# UNITED STATES PATENT AND TRADEMARK OFFICE

10/582,735

<b>Office Action Summary</b>	<b>Application No.</b> 10/582,735	<b>Applicant(s)</b> POWERS ET AL.	
	<b>Examiner</b> BRANDON M. ROSATI	<b>Art Unit</b> 3744

### **DETAILED ACTION**

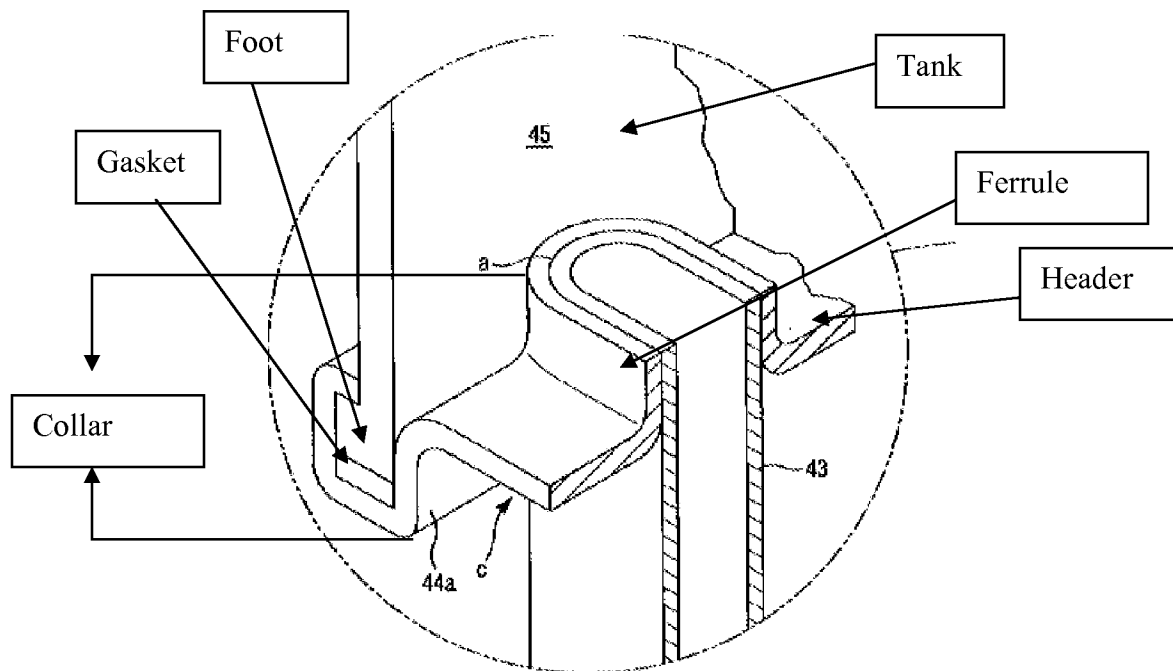
Regarding claim 10, Dey et al. disclose in Figures 4, 6b and 6c, a headering arrangement comprising a heat exchanger body (i.e. core) (23), a heat exchanger tank (45), a header (see Figure below), a plurality of tubes (43) extending from the heat exchanger body, a header pan (see Figure below), disposed at an end of the plurality of tubes, wherein the header pan has a plurality of slots, is flat, and defines a plurality of collars (see Figure below), each collar forming a ferrule surrounding and in contact with a respective one of the plurality of tubes, a tank foot, at the end of the heat exchanger part, a gasket (see Figure below), wherein each slot is formed with a respective one of the plurality of collars to accept a respective tube, the tubes pass through the slot and the slot and collar maintain the tank foot in place, and the plurality of collars are inverted in relation to a line of extension of the plurality of tubes. It is noted that the phrases "for a heat exchanger" and "for use in automotive application" are statements of intended use and the device is capable of performing the functions.

Regarding claim 14, Dey et al. disclose a gasket (see Figure below) which is essentially flat.

Regarding claim 12, Dey et al. disclose the header pan (see Figure above) comprising at least one flat medallion. It is noted that since the header pan of Dey is relatively flat, it therefore has a flat medallion. Furthermore, because the Examiner is examining the final product (i.e. the header pan), the steps utilized to make the final product, such as pressing, which is referred to as a medallion are given limited patentable weight in a an apparatus claim.
